## ADDENDUM TO OPERATION MANUAL FOR IQ 2000P

The following information is an update to the information in the operation manual. It includes changes and enhancements to the features/functions outlined in the operation manual.

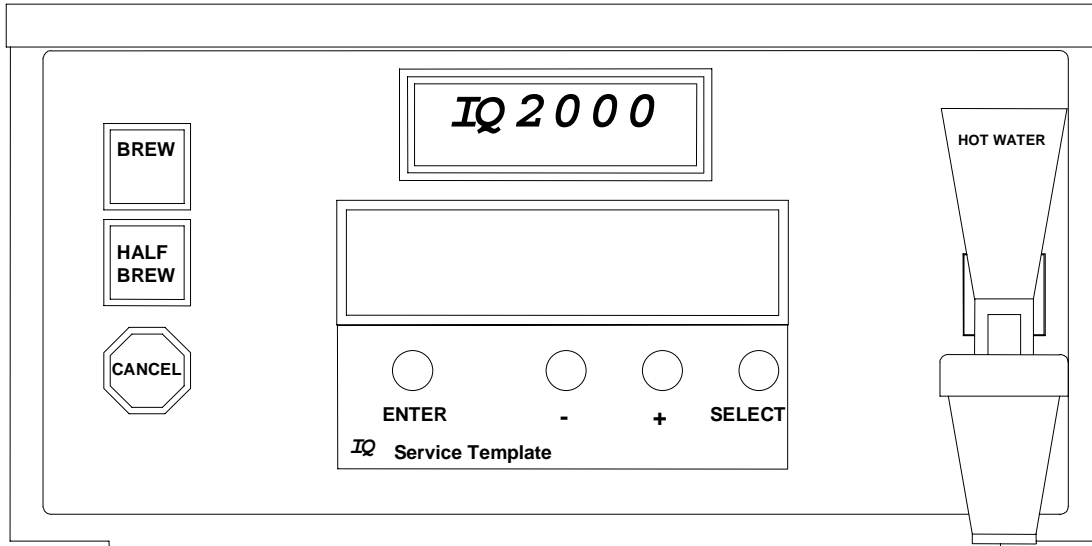
The functions of the 4 hidden buttons used for programming has been changed slightly. The figure below replaces Fig 1 on page 2 and illustrates the correct service template and button nomenclature.
